**HARROW COUNCIL**

**ADDENDUM**

**PLANNING COMMITTEE**

**DATE: 19<sup>th</sup> JULY 2023**

Existing and Proposed First Floor Plans

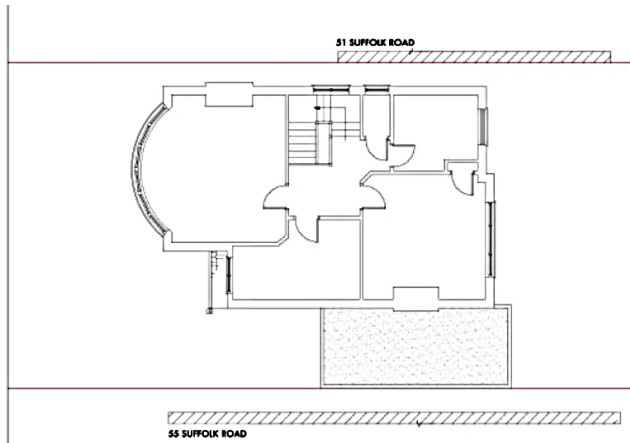
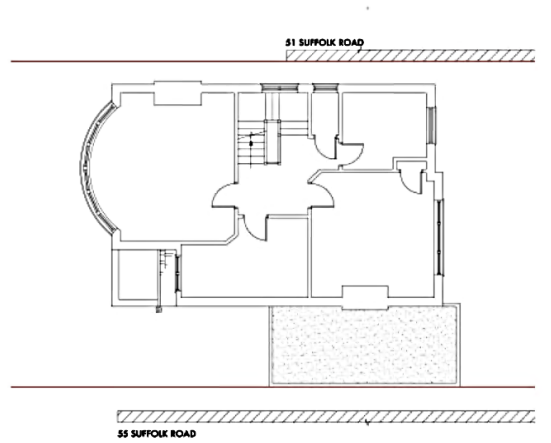
Substitute all of the existing and proposed plans and elevations within Appendix 4, with the following plans and elevations which have increased sharpness and visibility.

Existing and Proposed Rear Elevations

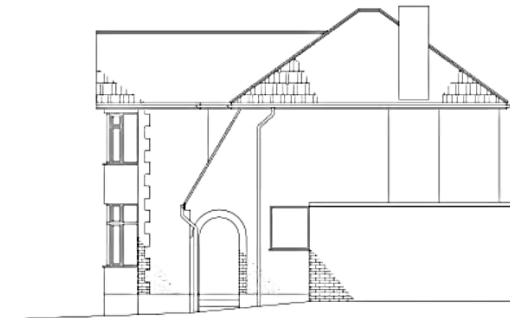
new extension would match  
the materials of the existing roof  
slate tiles

**02 Proposed Side Elevation**  
1:100

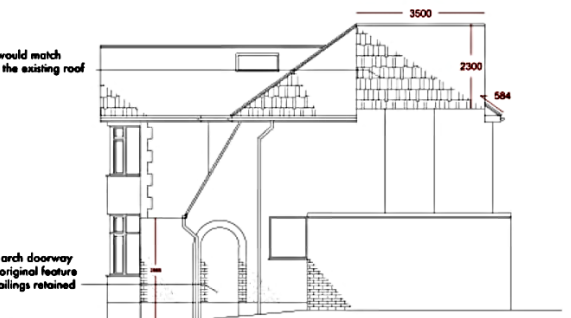
original arch doorway  
infilled, original feature  
and details retained
